Communication from Public

Council File No: 21-1502

VERMONT/WESTERN SNAP PROJECT PERMIT COMPLIANCE REVIEW SITE PLAN REVIEW

Case No. DIR-2016-3207-SPP-SPR

Figure 1.

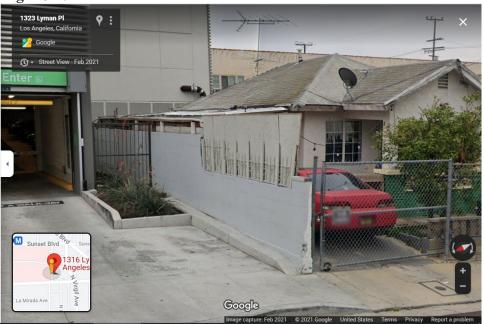
masonry wall adjacent to residential use and/or zones shall be constructed if no such wall exists."¹¹ The Addendum claims this measure has been implemented. ¹² But Figure 1 from CREEED LA's initial comments (pasted below) shows that the wall has not been constructed. The wall is not a decorative masonry wall, is not 6 feet tall through its entire length, and the residents of 1316 Lyman Ave supplemented this deficient wall with plywood.

The City argues that the Project is in compliance with MM XII-30, reasoning: "the portions of the original wall that predate construction, including the portion adjacent to the front of the home's driveway, may be less than 6 feet in height, as they were not required to be installed by Mitigation Measure MMXII-30." The City's interpretation of MMXIII-30 misinterprets the text of the measure, and fails to achieve the measure's purpose. MM XIII-30 requires a 6-foot-high solid decorative masonry wall be constructed "**if no such wall exists**." The word "such" refers to the 6-foot decorative masonry wall described in the measure. Here, a 6-foot tall wall does not exist, so the City was required to construct one. The City's strained interpretation of this measure fails to comply with the plain language of the measure, and fails to achieve its goal of mitigating noise impacts on a
